CS Memorandum No. 1324

To: Distribution
From: Susan MacKenzie, Document Control Manager 
Date: January 2, 2013
Reference: Project No. M544.1, Contract No. CS-149
Task No. 1-8.02, Change Control
Subject: Configuration Management Board Meeting No. 105

SUBJECT: Configuration Management Board Meeting # 105 – Rev. No. 0

116" utility that was encountered not shown on the UD plans to be abandoned on the Southeast Headwall of MOS

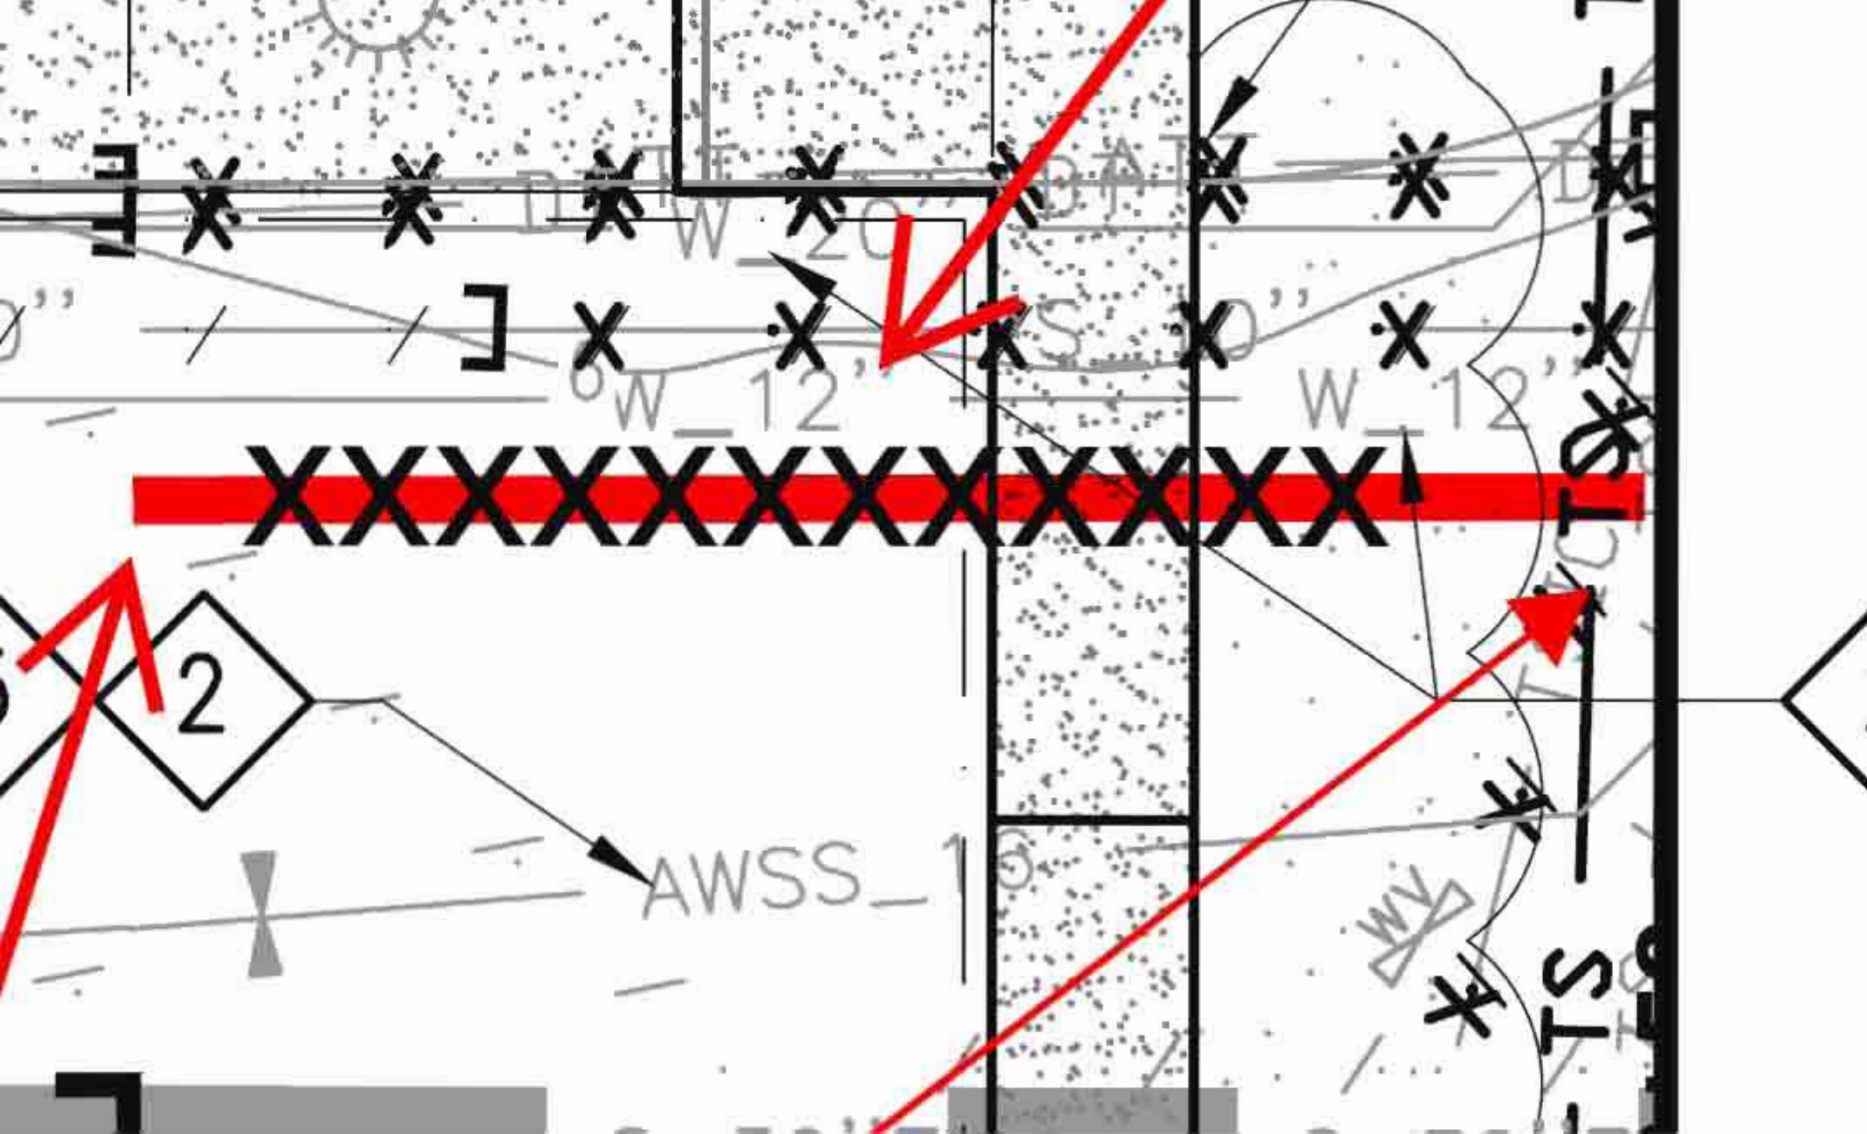
Justification: RE has evaluated the conditions outlined in Article 3.04 and found that: conditions differ materially and conditions have caused the scope of work to increase.

S:\6nocs03\m544.1\FinalDesign\Drawing-821\2-Civil\Utility Demolition\Sheet Files CP03\M54423UD701.dwg FBayani Wed Jan 26,2011 3:08 pm UD-701

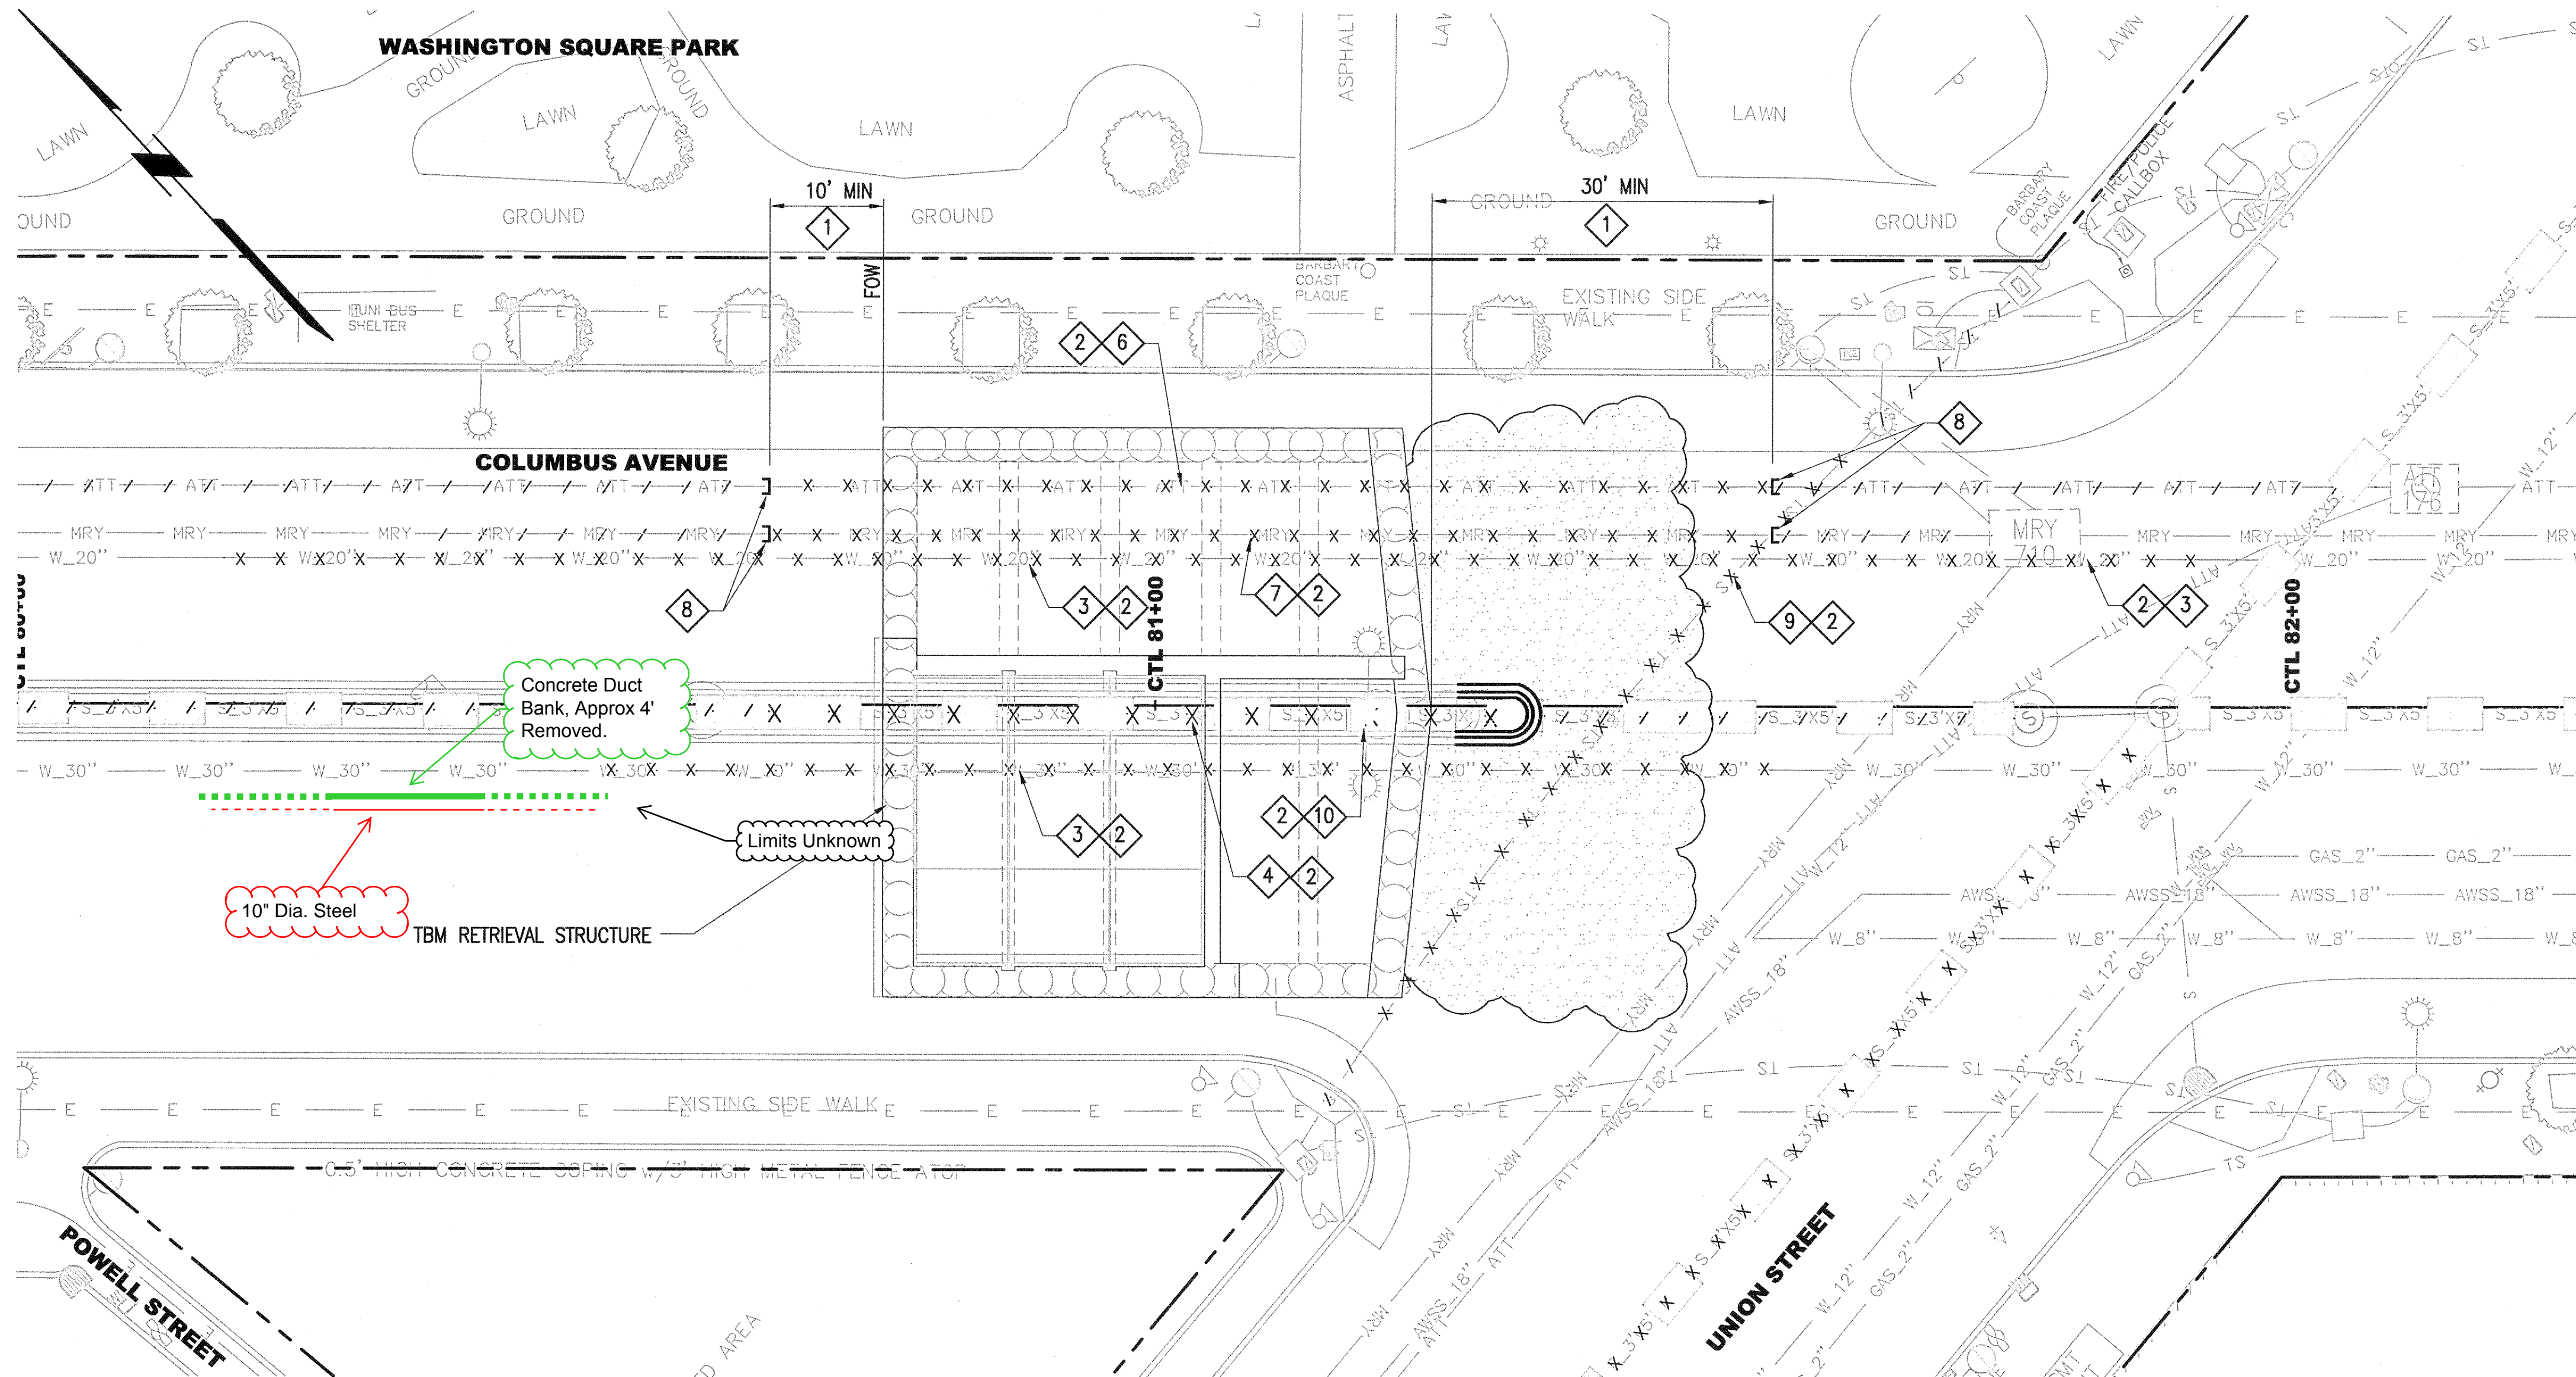
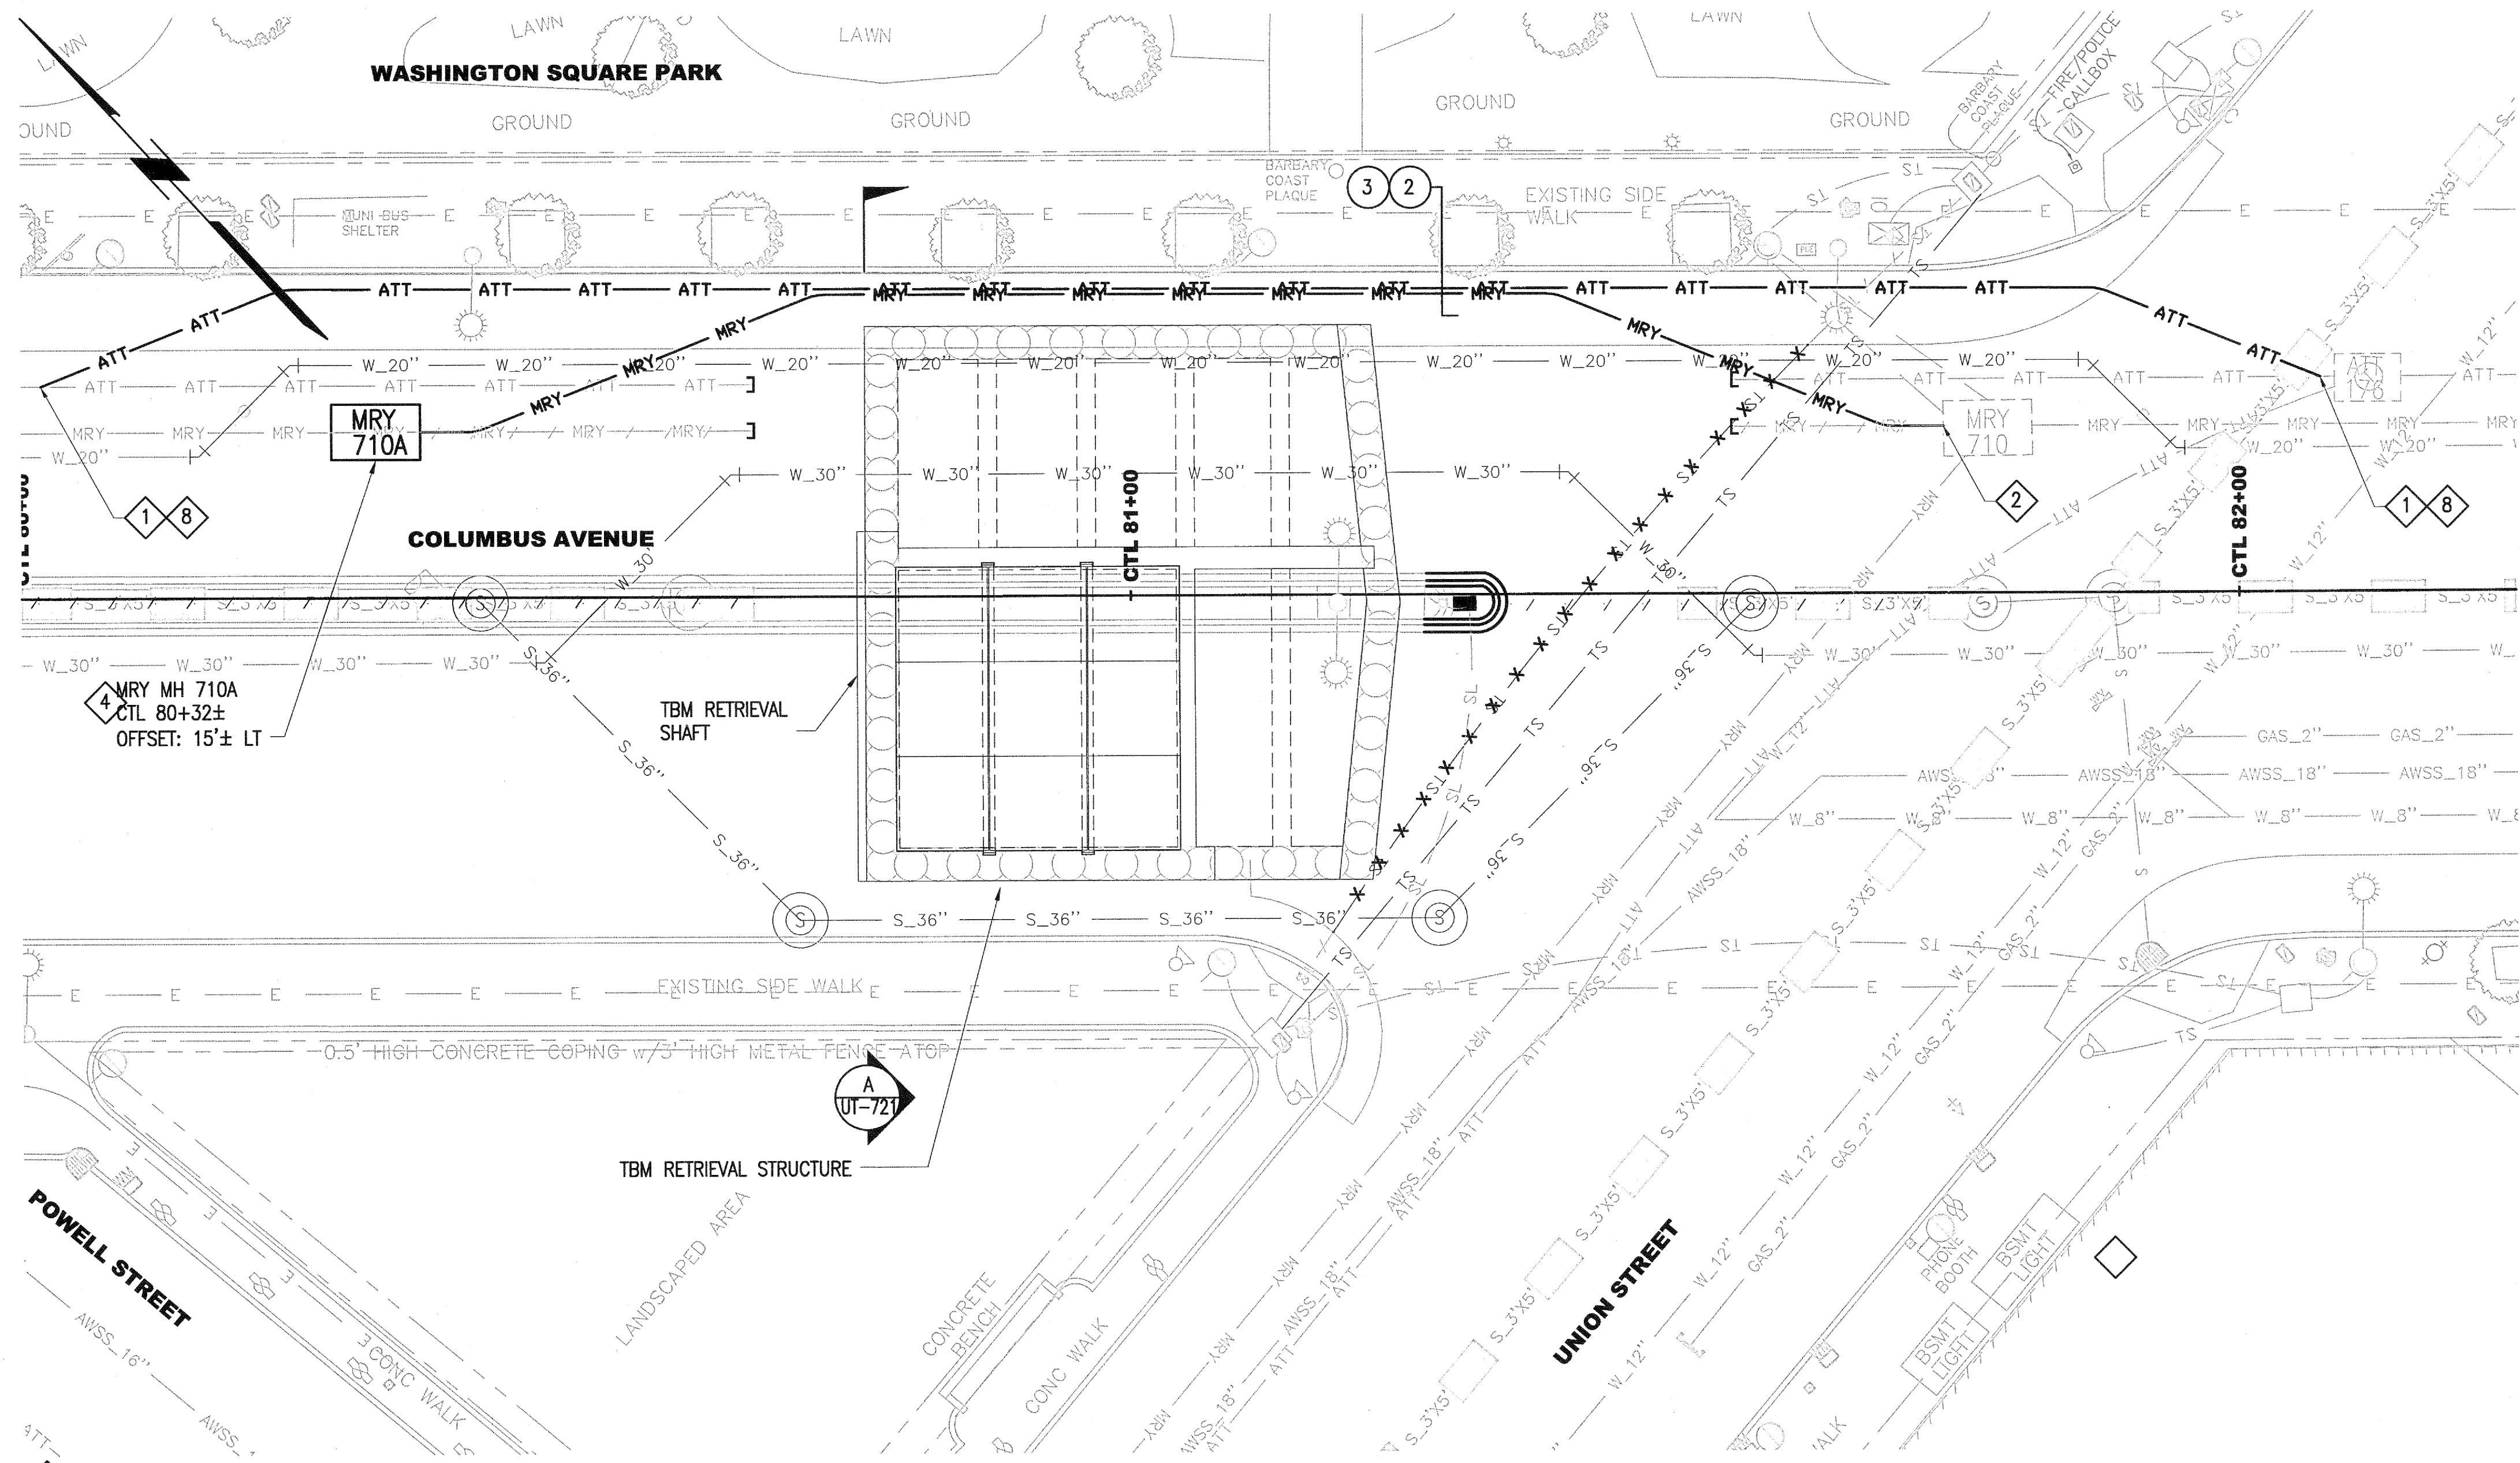
Contractor Rationale for COR: The Contractor contends that the three pipes and duct bank constitutes a differing site condition, as they were not shown in the drawings at the time of bid.

Justification: RE has evaluated the conditions outlined in Article 3.04 and found that: conditions differ materially and conditions have caused the scope of work to increase.
